Reply to Reviewer Comments

Reviewer 1:

Fig. 3. Research methodology for processing and analysis of debris flow seismic signal.

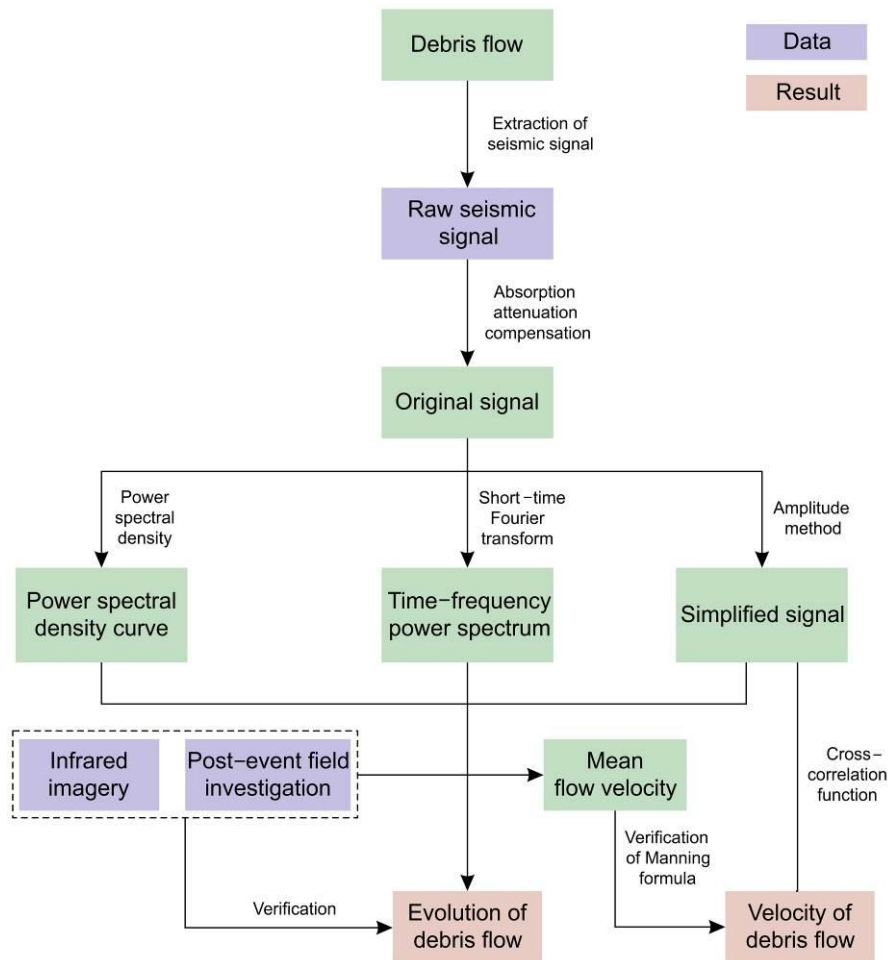
C41: The workflow in Figure 3 is not clear to me. Please follow the suggestions of the other reviewer

To extract information on debris flow evolution, debris flow seismic signals were processed and interpreted by following the procedure in Fig. 3. Absorption attenuation compensation is first to be processed for each frequency of the extracted seismic signal of debris flow to restore the different energy loss caused by different propagation, which was aimed to obtain the seismic signal of debris flow that is not affected by sensors installation location. Then, the seismic spectrogram is from compensated seismic signal based on short-time Fourier transform, characteristic analysis of debris flow evolution has been done by computing power spectral density of keyframe and the absolute value of time-domain amplitude, the evolution analysis result has been verified based on infrared imagery and post-event field investigation. Finally, the maximum velocity of debris flow has been estimated by computing the absolute seismic amplitude of different monitoring stations based on the cross-correlation function, which has been verified by the Manning formula. The key steps are outlined below in Fig. 3. Amplitude method in this figure is used to get the absolute value of time-domain amplitude in this figure. After this method, the signal processed by us is called a simplified signal.

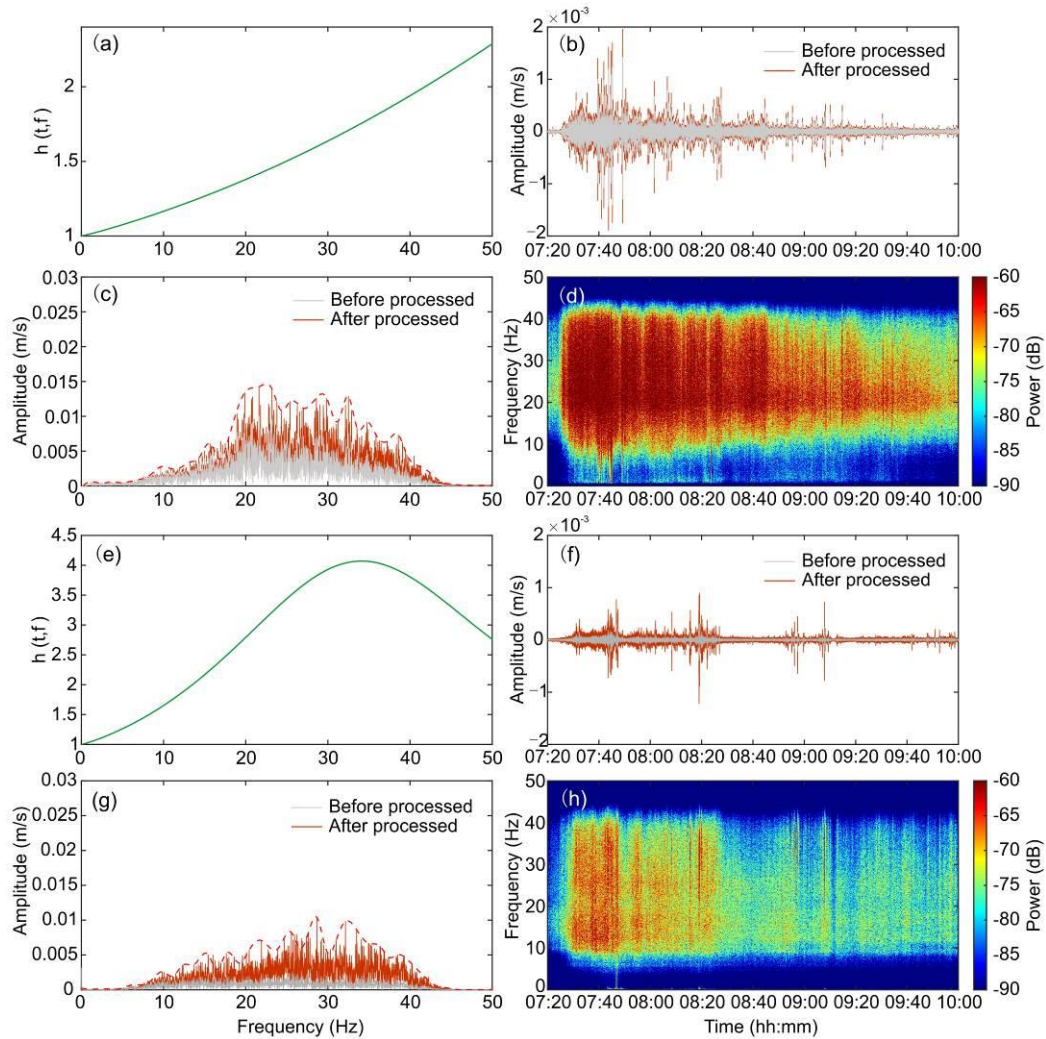
C58: Figure 6: more comments are needed for this figure. Why the function h is so different between a site to another? How do you interpret it? Please check the caption, I think that the number of the monitoring stations are not always correct. I also suggest to use spectrogram instead of “time-frequency domain energy spectrum”, which is also different from the vocabulary used in Figure 4

The figure and caption have been modified, as follows:

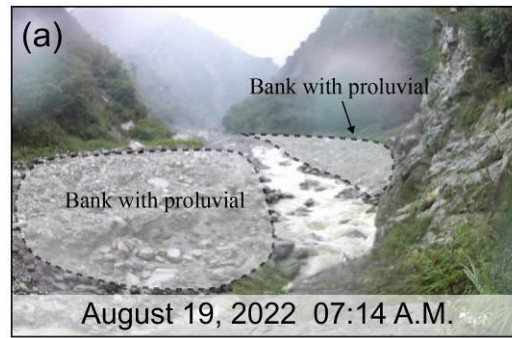
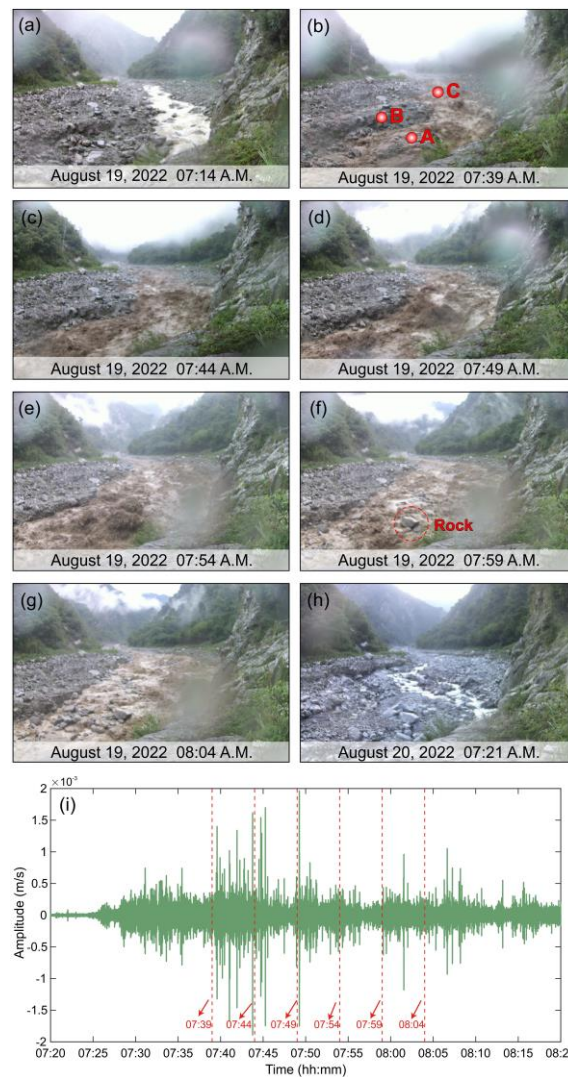
C63: Section 4.2.2: I find the use of the infrared camera interesting and I acknowledge your effort to get the maximum information possible from the images. However, I find most comments on the figure too speculative. How can you observe an increase in particle content from Figure 8a to 8d? How can you say that the flow velocity increases if images are static? I cannot see signs of erosion of the left bank you mention at line 388, and how can you see that the channel is smooth at point C (line 394)? I don't see a decreasing velocity after 7:39 (line 396), and the presence of a rock at point A is not sufficient to conclude that the transport capacity is low (lines 412-413).

Why have you analyzed only images from 7:39 to 8:04 given that the debris flow lasts longer? I think it is crucial to see the condition of the channel before the development of the debris flow. I suggest you to mark different part of the section before the debris flow (e.g. banks, sediment deposits), so that we can better visualize the changes and the magnitude of the event. It is also important to see images after the event: I wonder if the big rocks we see in [Figure 8f](#) are carried by the flow or just deposited.

The 6 images from 7:39 to 8:04 correspond to characteristic of the strong time-domain seismic signal at the 6 frames, these images are representative to analyze characteristic of debris flow. We have marking different part of the section before the debris flow ([Attached figure 1](#)), this figure is modified from [Fig. 7a](#) and not shown to avoid affecting clearness of the figure in the manuscript. Banks of the channel are covered with proluvial, which is from the previous debris flow or collapse. Images before and after the event are shown in [Fig. 7a, 7h](#), which can help us to visualize the changes and the magnitude of the debris flow better. It revealed that the big rocks we see in [Fig. 8g](#) are carried by the flow.

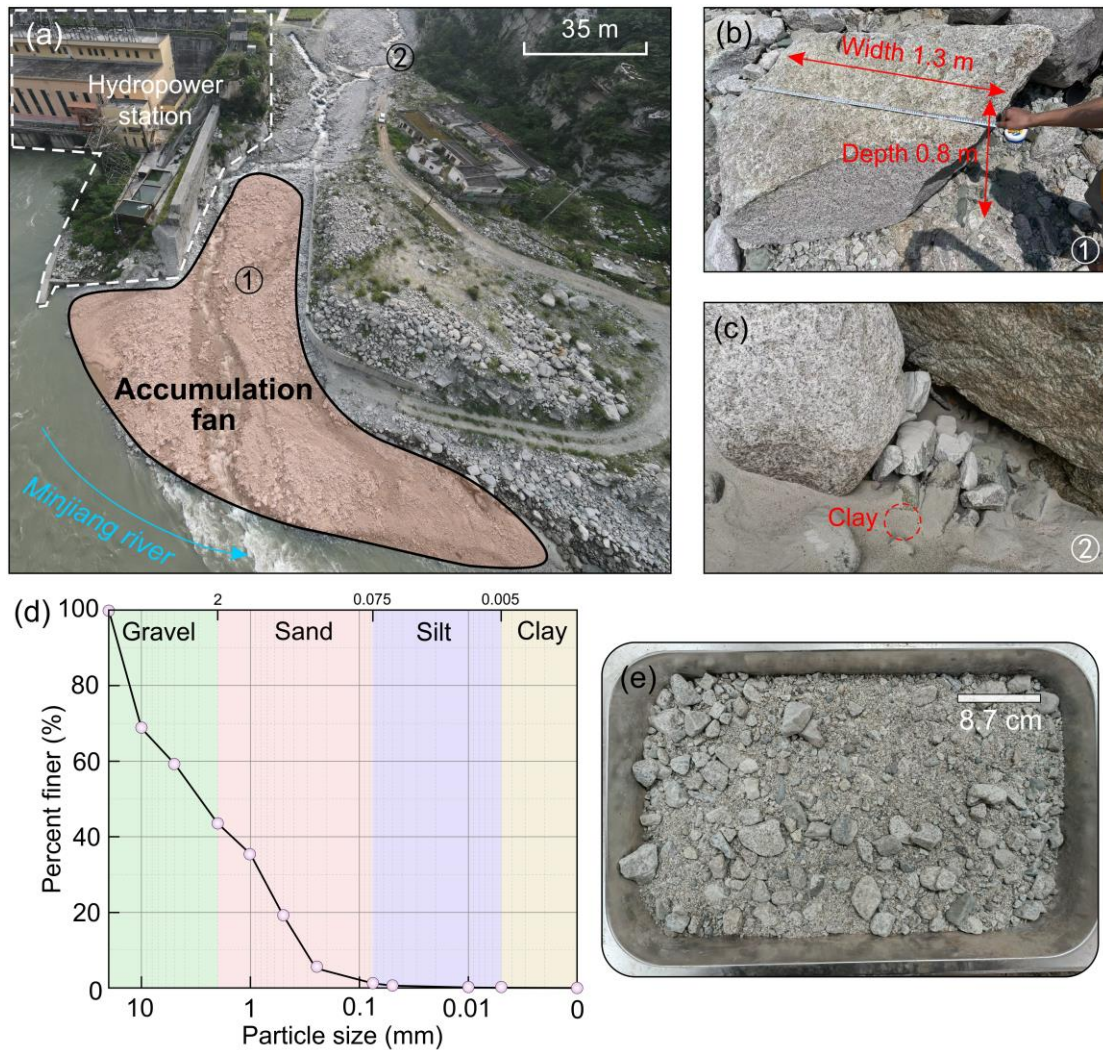
C69: Figure 9: In Figure 9a you use “deposition fan”, in the caption you use “accumulation fan”. Please choose one of them.

R69: Thank you for your useful advice. The figure has been modified, as follows:

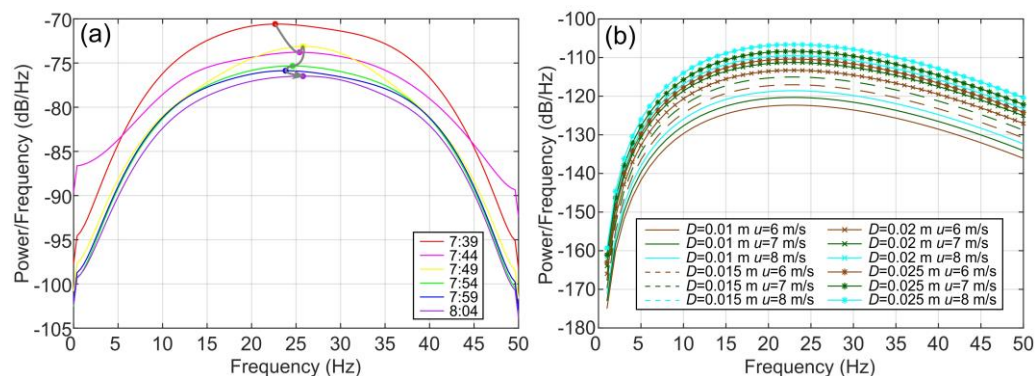
C70: Section 4.2.4: I'm sorry but I'm not sure about the need of this section. The changes you claim to see in Figure 10 are really small, especially from 7:44 to 08:04, maybe less than 1 decibel. I believe that this can be within the errors associated with your computations. If you want to investigate the variation of frequency over time, maybe you could compute the frequency peak or the mean frequency as in Farin et al.

Eq. (6) was employed to calculate the seismic Power Spectral Density (PSD) curves for the six-time points corresponding to the infrared images (Fig. 9a). Notably, the maximum energy within the main frequency band (15~30Hz) exhibited a gradual decline from 7:39 to 8:04, evident from the discernible trend in dot changes depicted in Fig. 9a. The width of the PSD spectrum demonstrated an initial increase, followed by a subsequent decrease, showing distinct trends between the low-frequency and high-frequency bands. Specifically, the high-frequency band (>30Hz) experienced a gradual reduction from 7:39 to 8:04, characterized by a rapid decrease from 7:39 to 7:49 and a relatively slower decline from 7:54 to 8:04. Conversely, the low-frequency band (<15Hz) exhibited a substantial increase from 7:39 to 7:44, followed by a more substantial decrease leading up to 7:54, after which it roughly remained unchanged. These varying characteristics among different frequency bands underscore the need for a deeper understanding. In the subsequent sections, we will employ a debris flow seismic PSD forward model to gain a more comprehensive insight into these observations.
